R09PM

SUBJECT: RECALL R09PM OFFSET LEG BARRIER PAD AND 2/3 PASSENGER SEAT BACK PAD NONCOMPLIANCE

Offset Leg Barrier & 2/3 Seat Back Pads

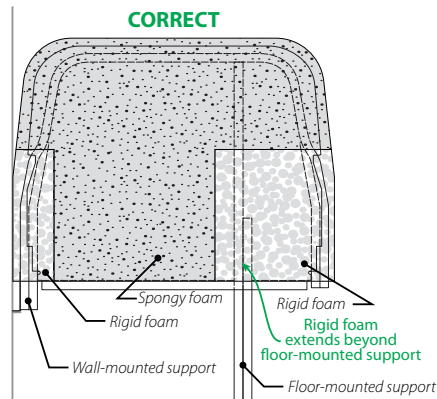
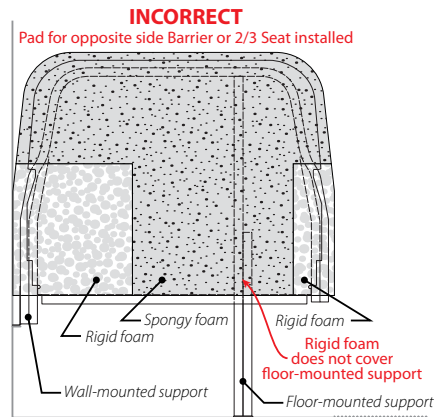
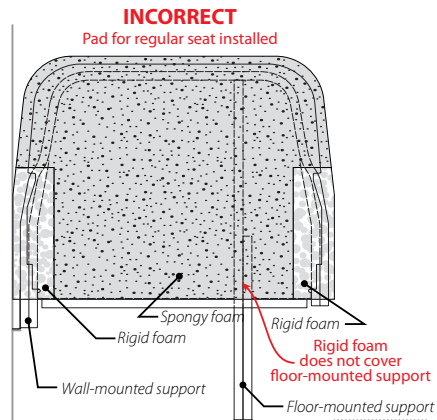
On some affected buses, Barriers and/or 2/3 Seats with offset floor-mounted supports may have incorrect foam pad assemblies installed, resulting in a noncompliance with FMVSS 222 S5.3.2 Leg Protection Zone.

- Correct Pads For Barrier and 2/3 Seat Backs. The offset support legs of Seat Barriers and 2/3 Seat Assemblies extend vertically inside the back frame. These vertical frame members are required to be covered by the rigid foam components of the Pad Assembly.
- Incorrect Pads For Barrier and 2/3 Seat Backs. If a Pad Assembly for a regular full-width seat is installed on a Barrier, or on a 2/3 Seat Back, the vertical extension of the support legs are not sufficiently covered by the rigid foam type.

The edge of the rigid foam inside the cover of a Barrier or a 2/3 Seat extends beyond the vertical support leg, which is offset from the aisle-side of the seat.

The pad of a regular seat back also has rigid foam pieces, but they do not extend as far from the aisle-side of the seat, because the vertical support leg is not offset.

2 Inspect each Left and Right Offset Leg Barrier and each 2/3 Seat Assembly to ensure the correct Pad Assembly is installed:

2.1 On the rear side of the Barrier or Seat Assembly back, starting at aisle-side lower corner, press a hand near the bottom edge and move slowly toward the middle of the back. A change in softness can be easily felt where the rigid foam ends and the spongy foam begins. Mark this location, and compare it to the location of the offset leg portion of the frame.

- If the rigid foam spans beyond the offset leg, the correct Pad Assembly is installed, and no rework is required.
- If the rigid foam does not extend beyond the offset leg, an incorrect Pad Assembly is installed, and must be replaced with a correct Pad Assembly. Proceed to Step 3 to perform the Pad replacement on a Barrier Assembly. Proceed to Step 4 to perform the Pad replacement on a 2/3 Seat Assembly.
